Fort Mill School District Addendum #2	Solicitation Number: #23-007
		Date Issued: December 15, 2023 Procurement Specialist: Kelly Keniston Phone: (803) 548-8202 E-Mail Address: kenistonk@fortmillschools.org

DESCRIPTION Springfield Middle School Cooler & Freezer Enclosure Replacement

Addendum #2 is being issued to answer questions submitted by bidders and include additional information for the contract set of documents.

4 CEILING PLAN
A30 1/8" = 1'-0"

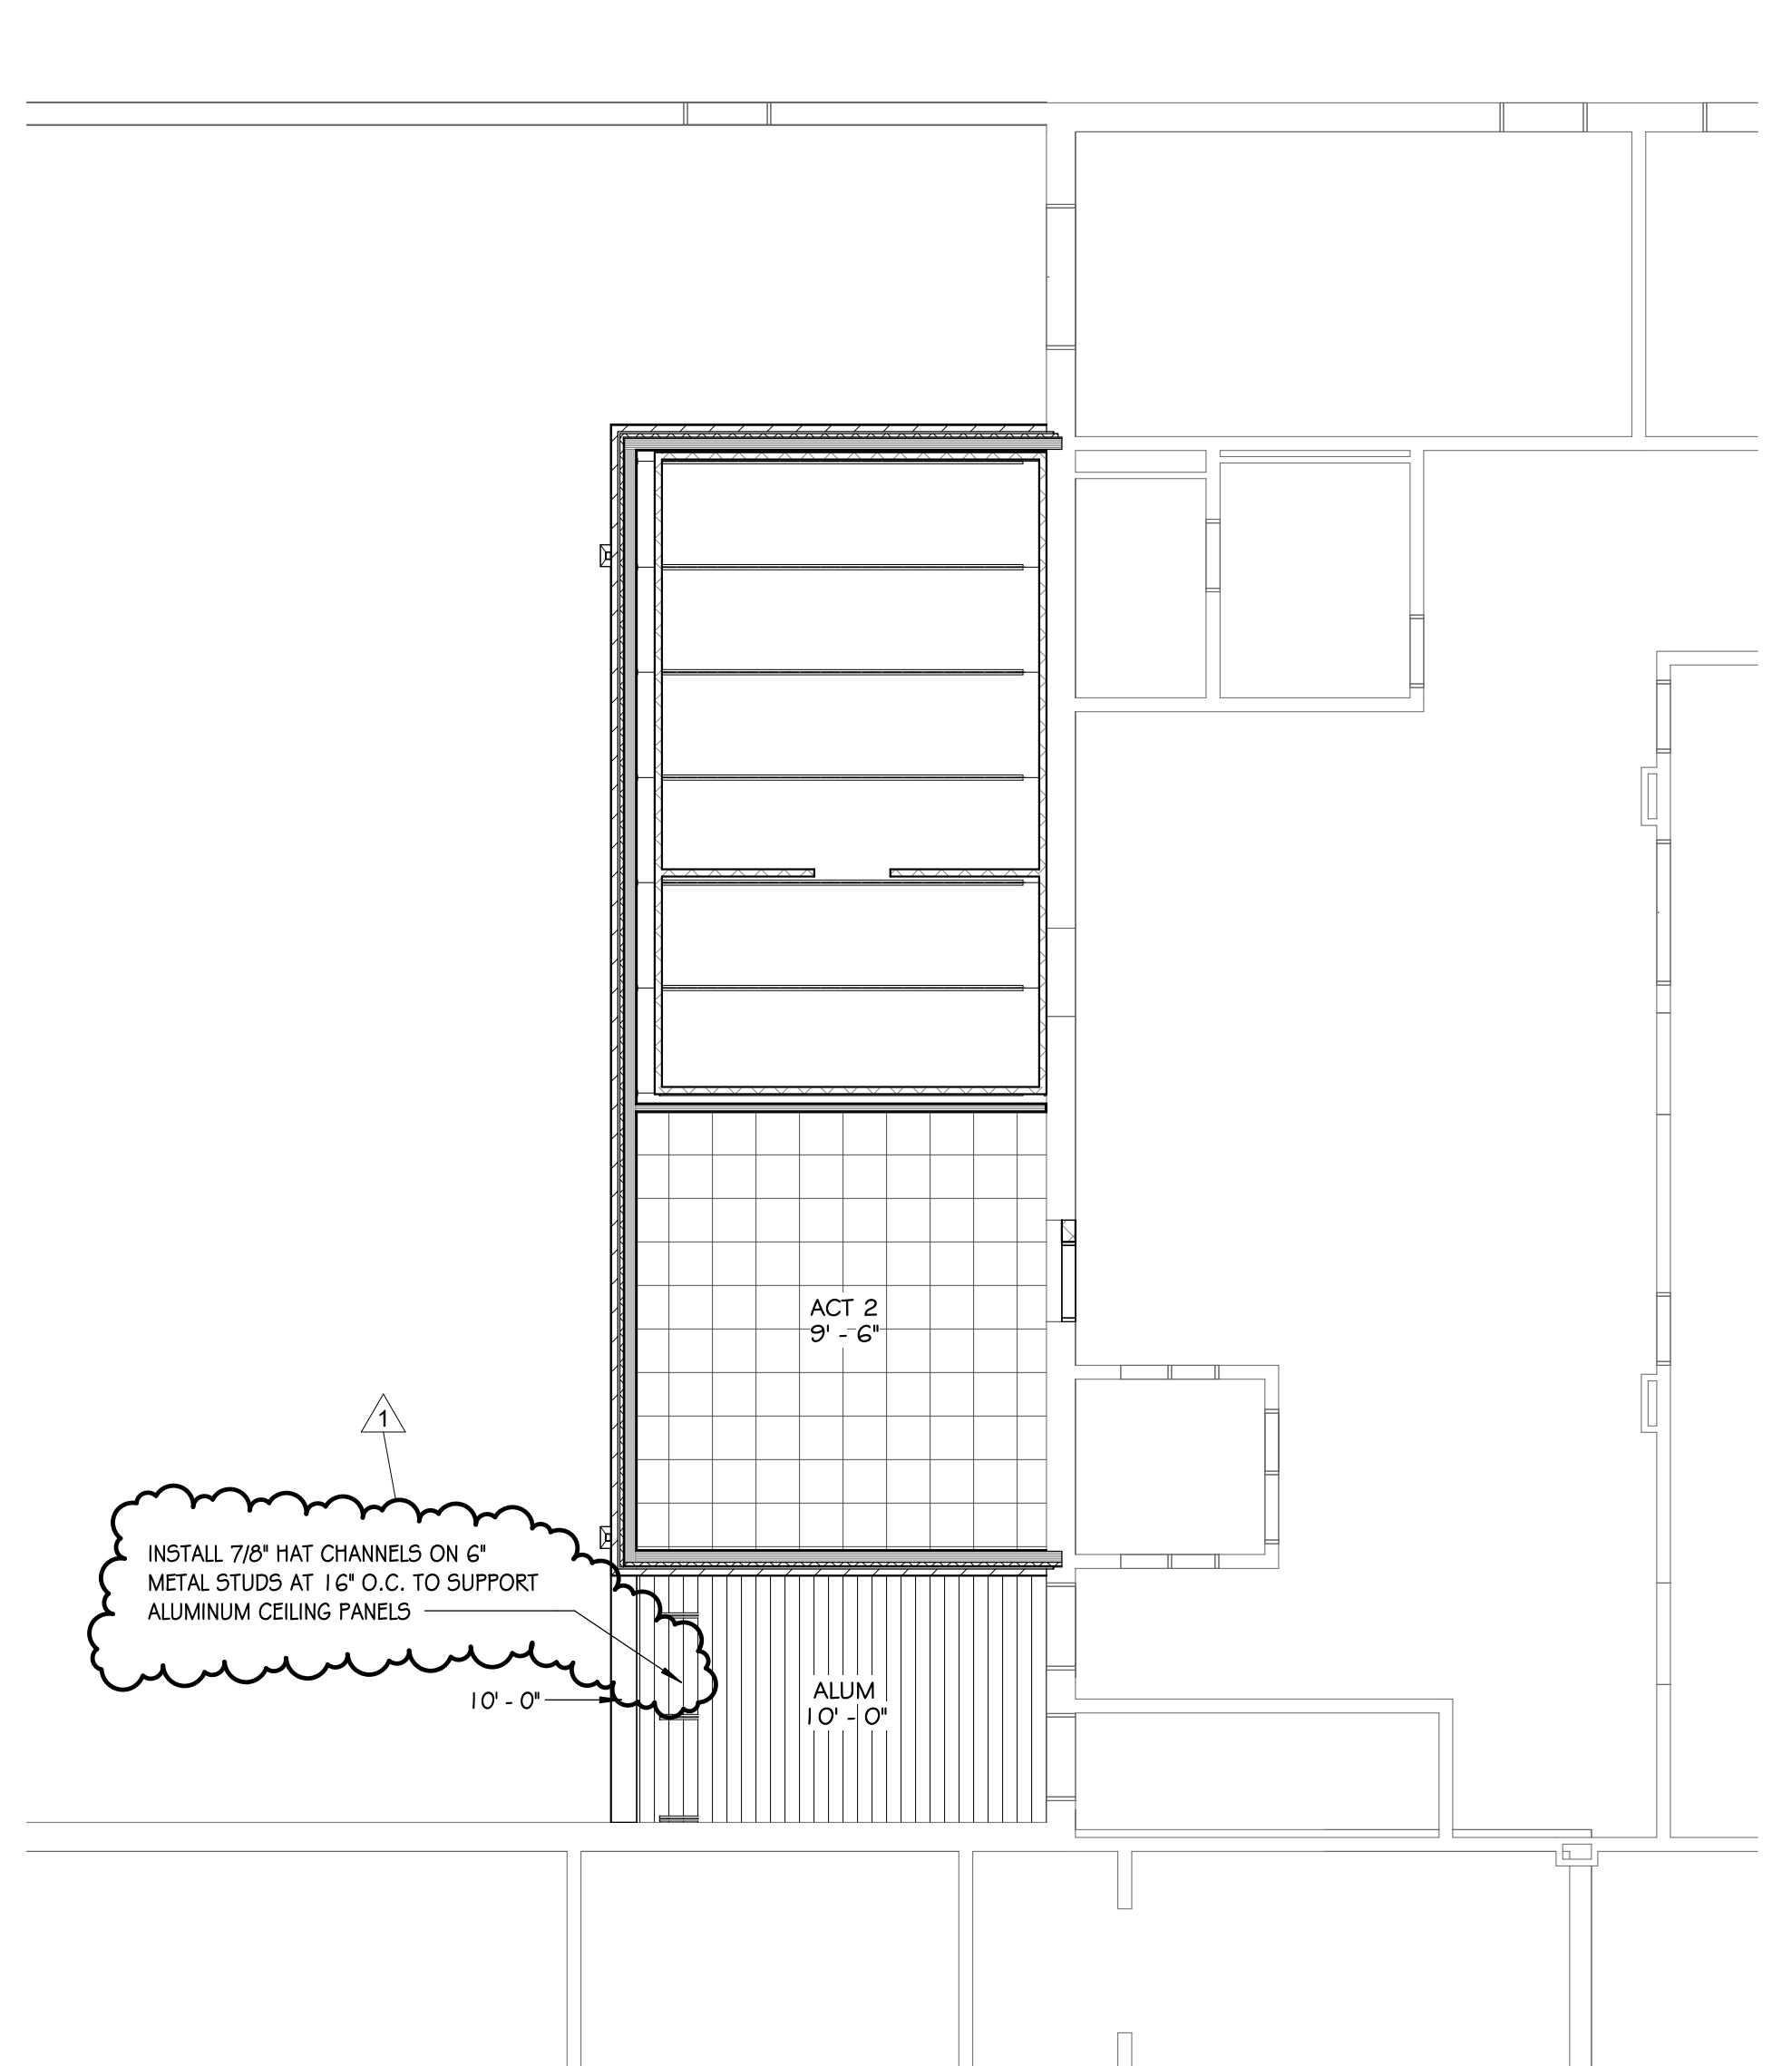
Please confirm the Aluminum product shown in Detail 4 on Sheet A301. There is no specification for aluminum panel within the specifications?

Floor Plan 2/A301 or Ceiling Plan 4/A301 does not provide a section detail to reference for the overhang above the 2 doors leading outside next to the new structure. There is no spec for this item either. It is also not clearly shown on the Front Elevation 1/A302. Please advise?

A: SOFFIT PANELS

- A. Soffit Panels: 22-gauge metal panels with where required with 12" coverage utilizing male/female-interlocking connection. Panels shall have smooth texture. Fasteners shall be concealed and approved by the manufacturer for use in the metal types. Finish shall be 70% flouropolymer, Kynar 500®. Color and trims shall be as selected by the Architect. Isolate dissimilar metals.
- B. Framing: Provide 7/8" Hat Channels on 2-1/2" Metal Studs at 16" o.c.

A: Please refer to the revised sheet A301 and the following specification information below for the Aluminum soffit panels.

A. Soffit Panels: 22 gauge metal panels with where required with 12" coverage utilizing male/female-interlocking connection. Panels shall have smooth texture. Fasteners shall be concealed and approved by the manufacturer for use in the metal types. Finish shall be 70% flouropolymer, Kynar 500®. Color and trims shall be as selected by the Architect. Isolate dissimilar metals.

3 WALL SECTION - 01
1" = 1'-0"

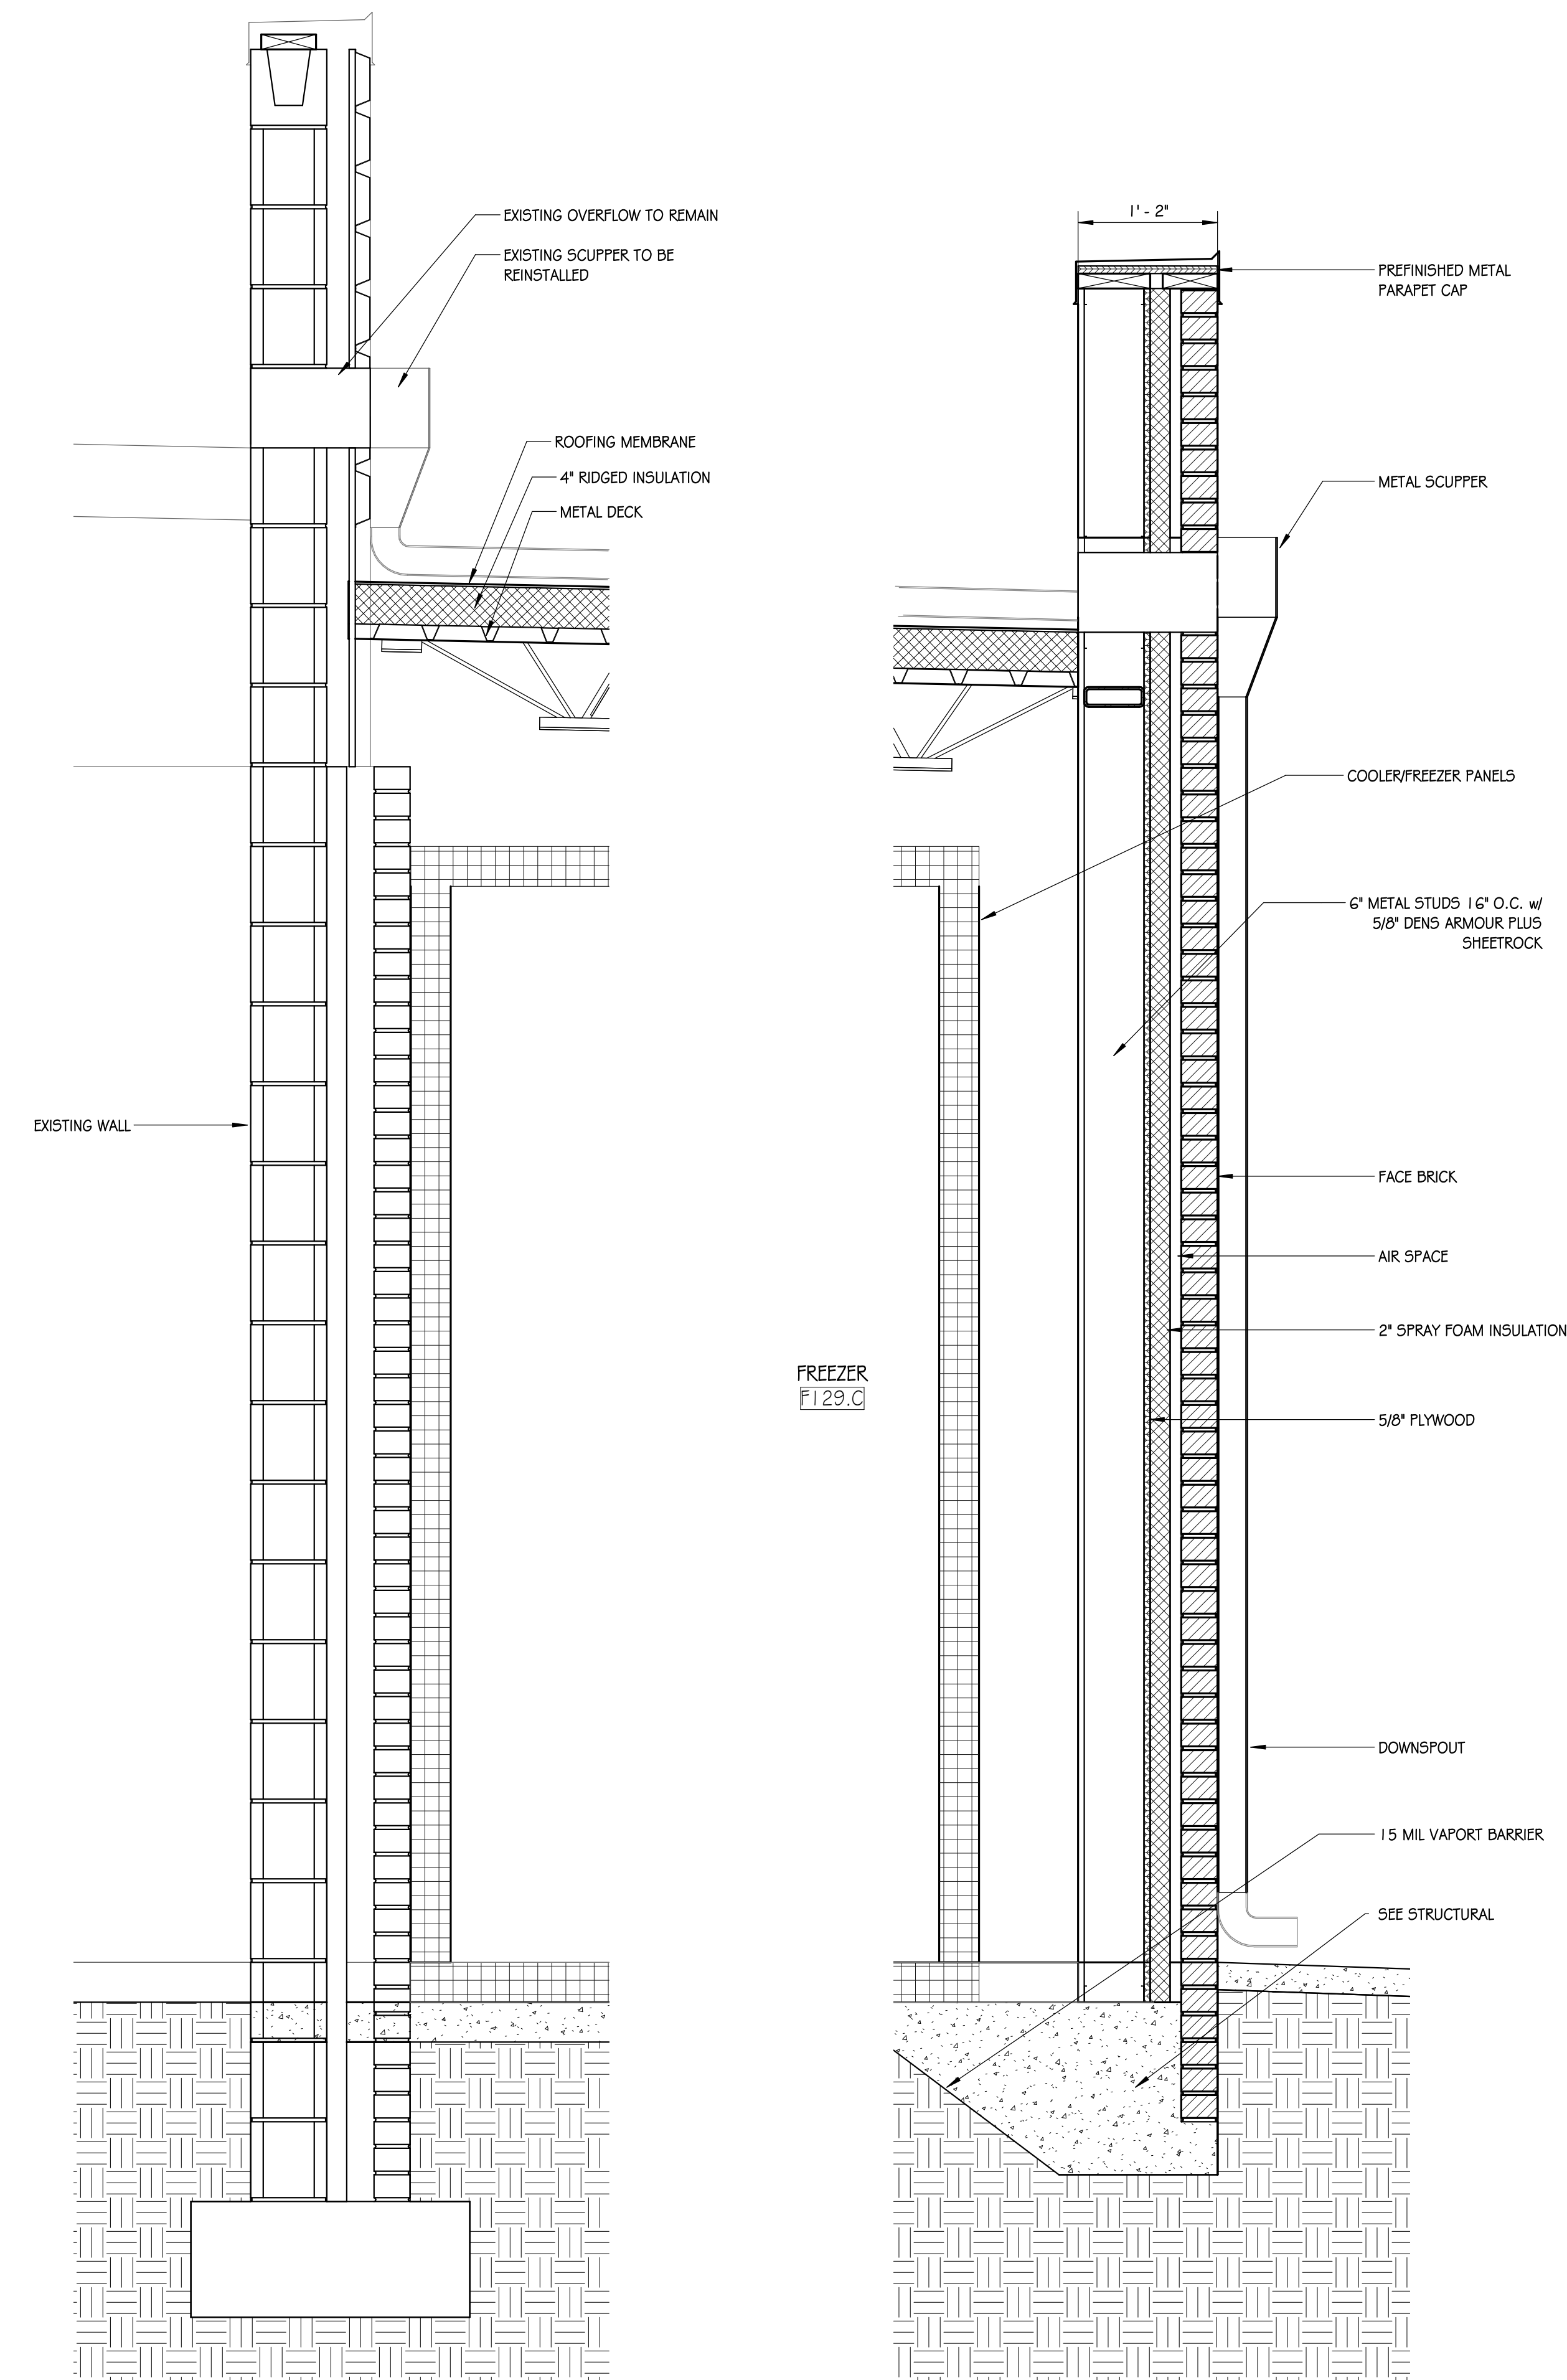
Wall Sections 3/A302 seems to show the downspouts from the school roof connecting to the scuppers from the new cooler/freezer roof. That is not shown on the Roof Plan 3/A301. Are they to be installed to the drains similar to what is on the existing structure??

A: Please refer to the revised Sheet A301 / Detail 3 indicating the routing of the roof leaders from the upper roof to the new down spouts for the New Cooler & Freezer roof. These items are required to be piped across the new roof, similar to the existing installation.
